**PROJECT: MIDDLE SCHOOL MEDIA CENTER RENOVATIONS
AL STANBACK MS, GRAVELLY HILL MS, ORANGE MS**

CRA PROJECT #: 2601.01, 2601.02, 2601.03

DATE: 4/1/2026

MODIFICATIONS TO THE CONTRACT DOCUMENTS FOR THE ABOVE-NAMED PROJECT SHALL BE MADE AS DESCRIBED BELOW AND SHALL BE INCLUDED IN THE BID AMOUNTS:

A100

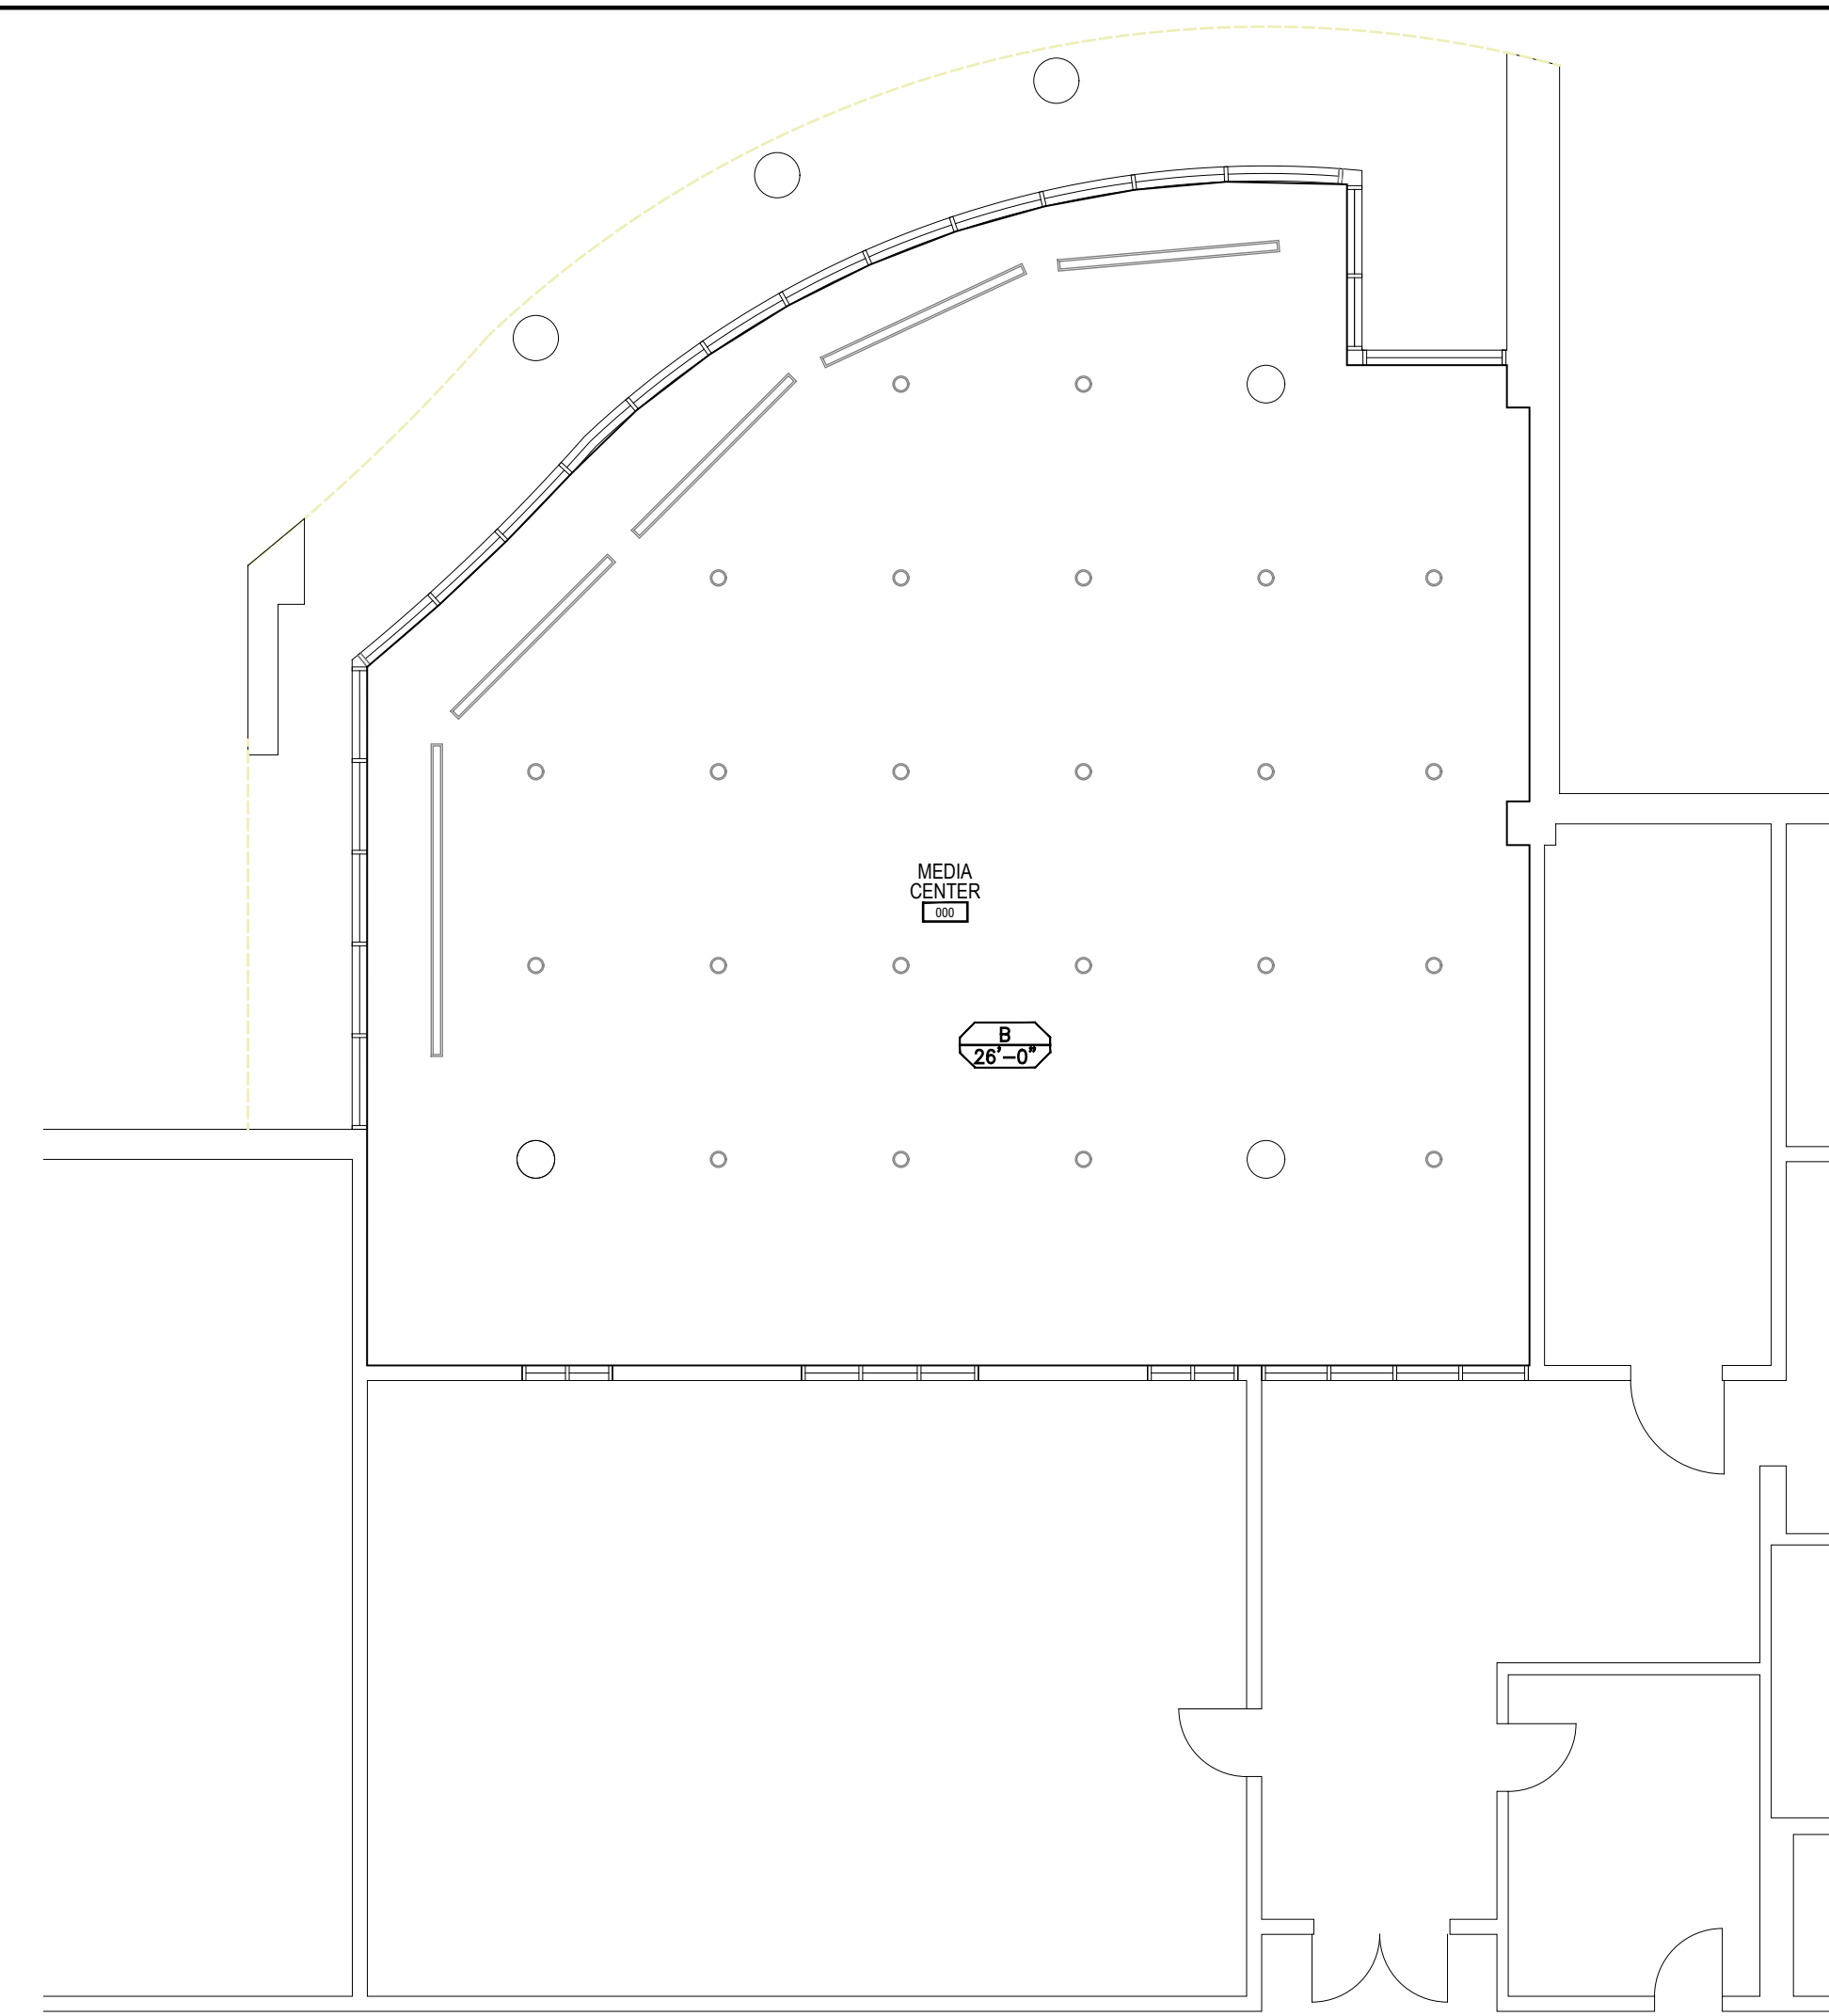
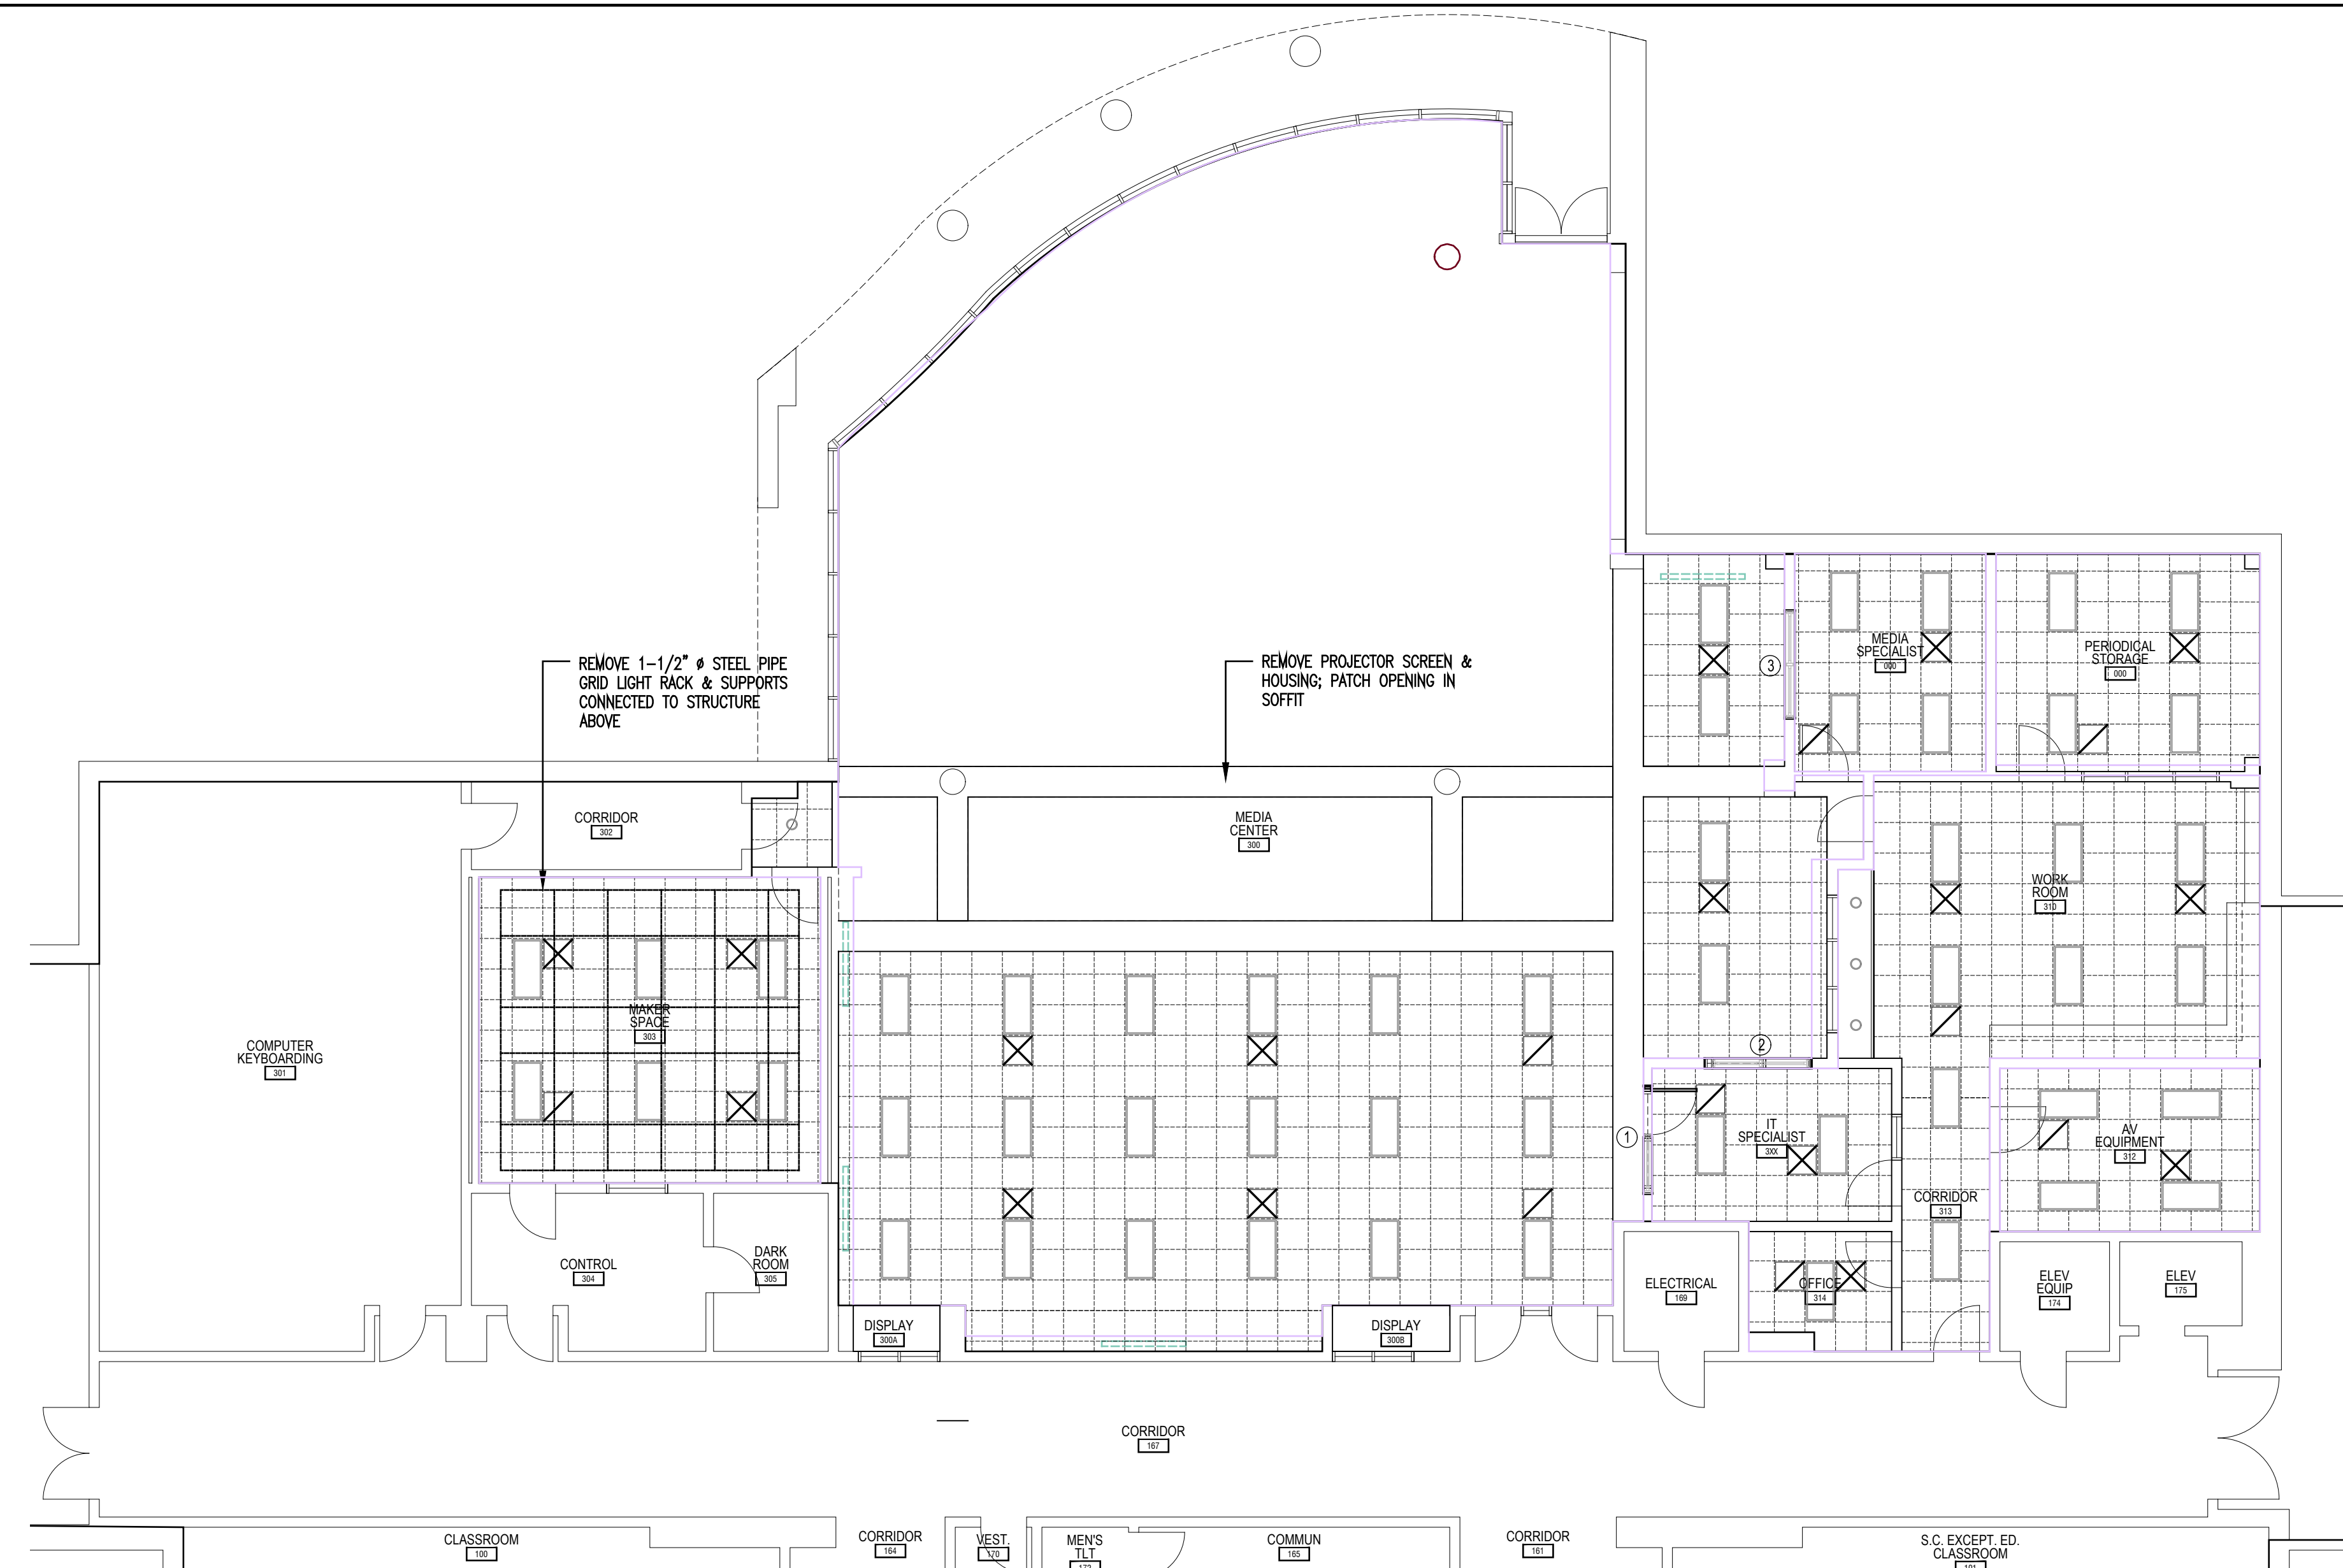
27	AL Stanback Gravelly Hill Demo Media Cases	Reference revised dwgs for AL Stanback--Contractor shall demolish doors and frames and provide sheetrock cased openings and soffits at former display cases. Prep and paint all sides of HM window frames.	4/1/26	
End of Clarifications			4/1/26
